## Martha's Vineyard Commission

### **Re: LUPC approval of DRI 696 Landscape and Lighting Plans**

# Schematic Site Plan in WEST TISBURY, MASS.

## Sheet 3 of 4 - Lighting Plan

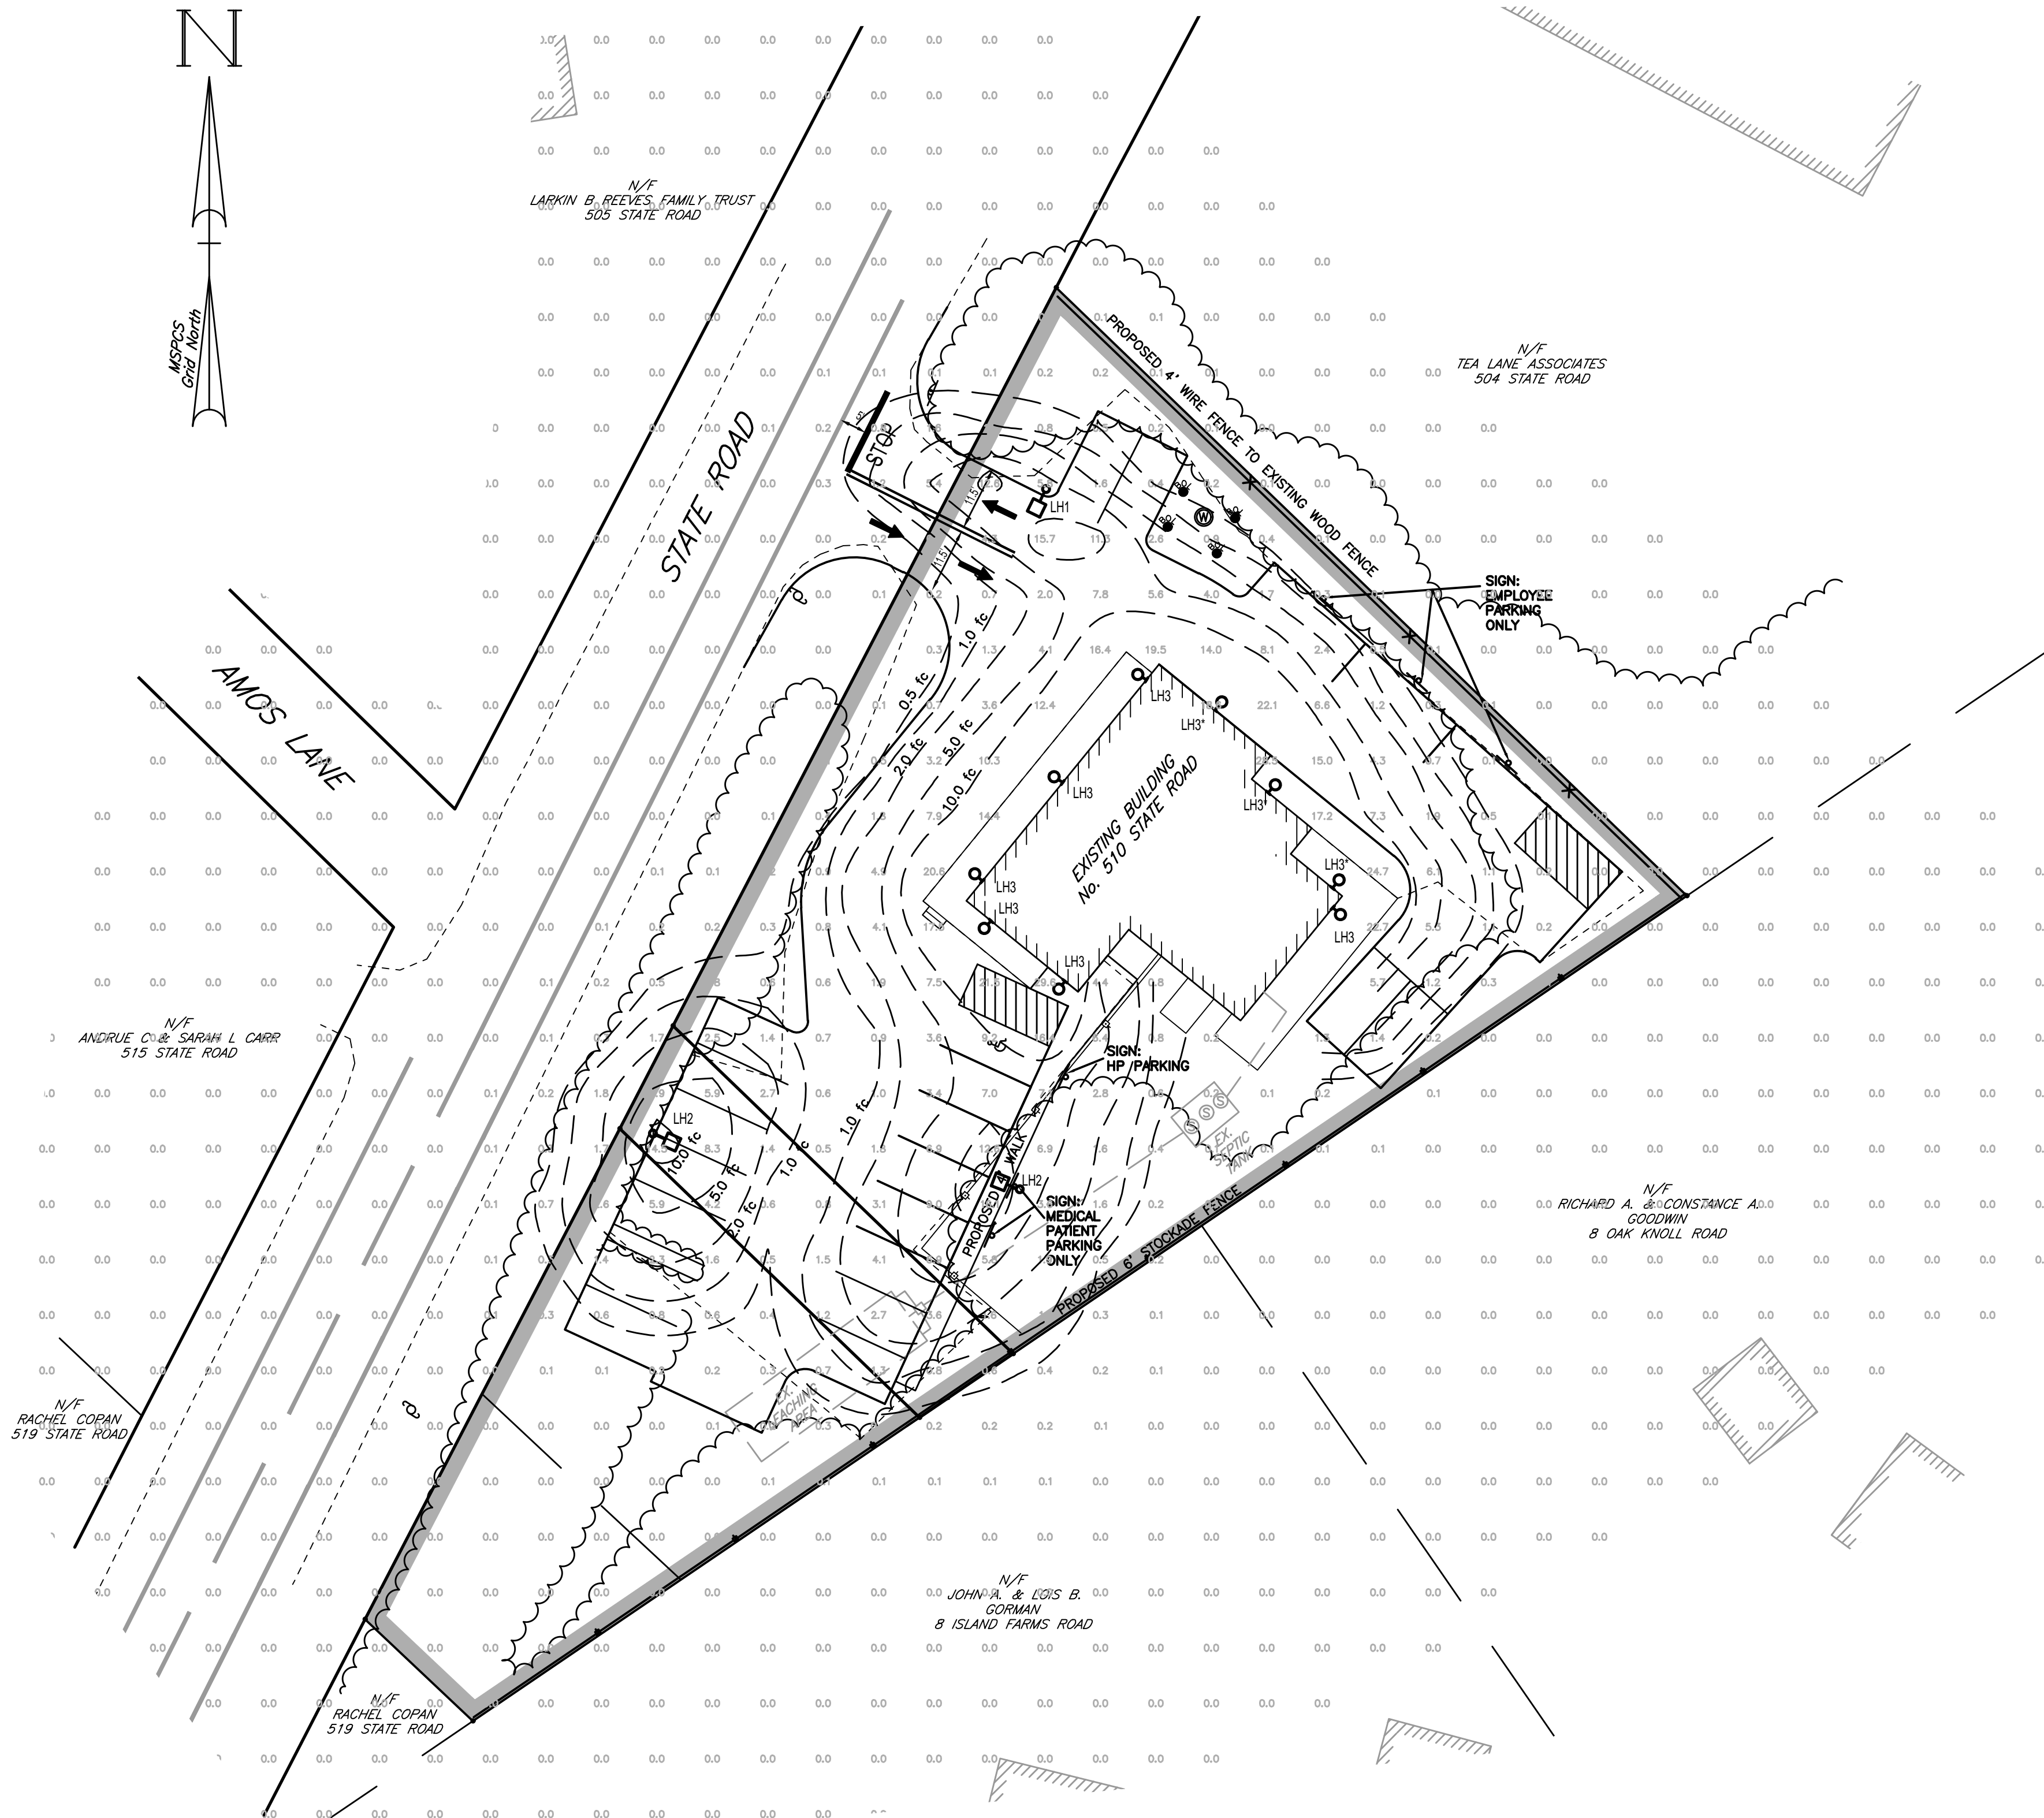
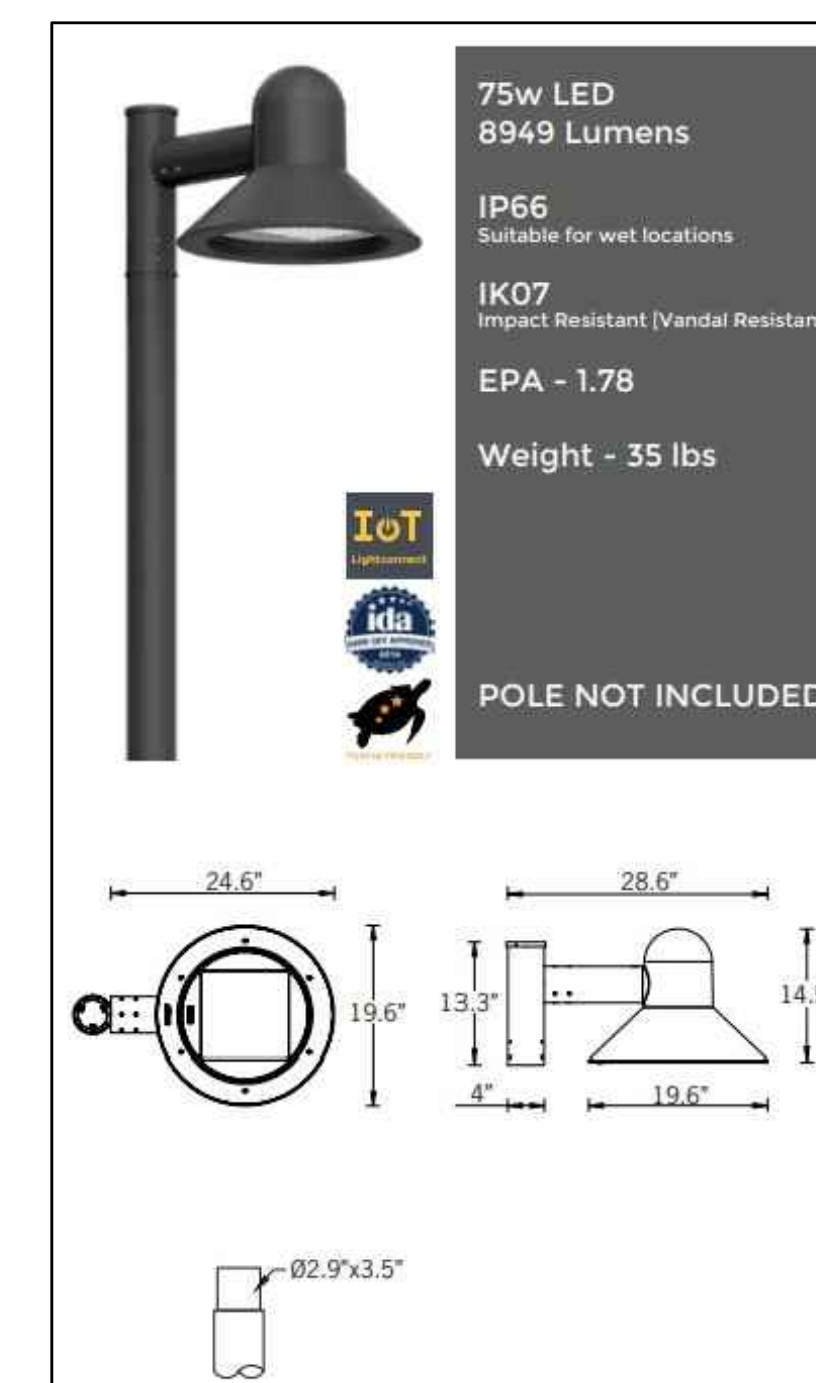
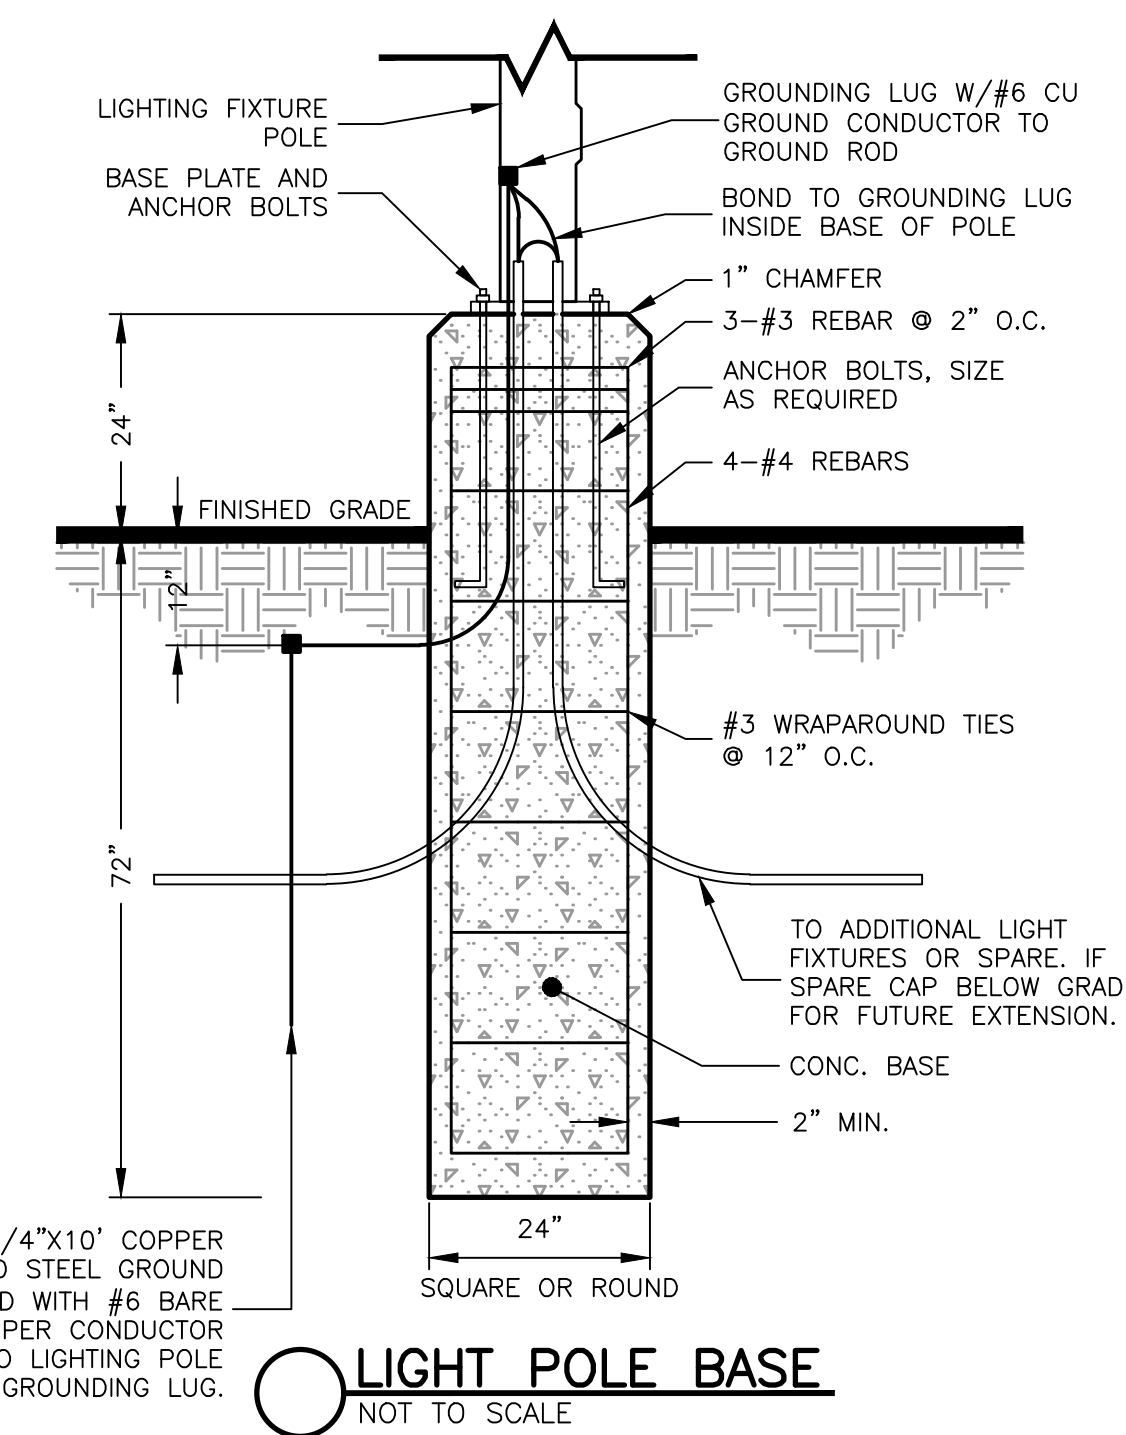
To follow up on my letter from June 22, 2021, I am writing to confirm that an updated lighting plan for 510 State Road, dated July 15, 2021, has been reviewed by MVC staff and Commissioner Fred Hancock, as requested by the Land Use Planning Committee on June 21, and we have accepted the revisions. The revised plan (attached here) adjusts some of the lighting fixture locations and circuitry, includes additional wall-mounted lights, and shows more visually appropriate fixture types. In addition, none of the fixtures will exceed 3,000 Kelvin in terms of color temperature. With these changes, the LUPC review of the lighting plan is complete, and no further review by the LUPC is required at this time.
